Groundwater Application Review Summary Form

Application # G- 19172

GW Reviewer Joe Kemper Date Review Completed: 1/8/2024

TO: Water Rights Section Date 1/8/2024
 FROM: Groundwater Section Joe Kemper
Reviewer's Name
 SUBJECT: Application G- 19172 Supersedes review of 3/11/2022
Date of Review(s)

Stream Depletion Modeling

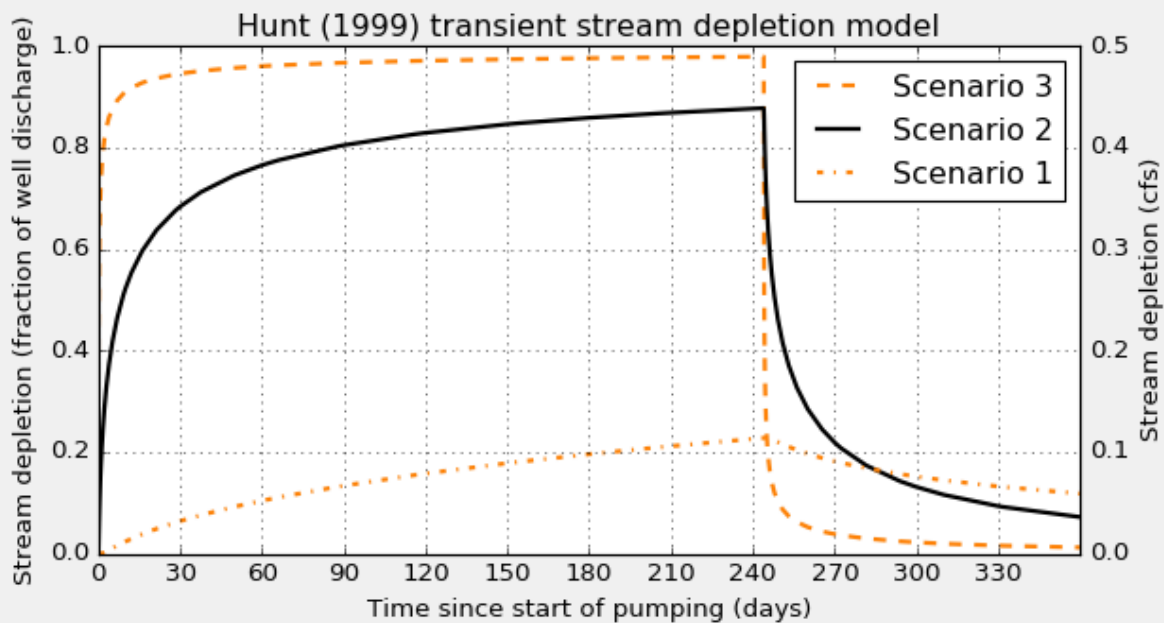
Comments: Stream depletion is estimated using the Hunt (1999) model using aquifer parameters representative of bulk aquifer properties in a fractured-intrusive hydrogeologic setting.

C6. **SW / GW Remarks and Conditions:** The applicant's well accesses an aquifer that is determined and assumed to be hydraulically connected to Pleasant Creek. The proposed use is found to have the Potential for Substantial Interference (PSI) with Pleasant Creek by the following metrics as outlined in OAR 690-009: the well is located within ¼ mile of a surface water source, the requested rate (0.045 cfs) is larger than 1% of the expected natural stream flow (1% of 0.35 cfs or 0.0035 cfs), the requested rate (0.045 cfs) is larger than 1% of adopted instream flow (1% of 0.52 cfs or 0.0052 cfs), and the estimated stream depletion after 30 days is greater than 25%. Reducing the requested rate will not avoid a finding of PSI.
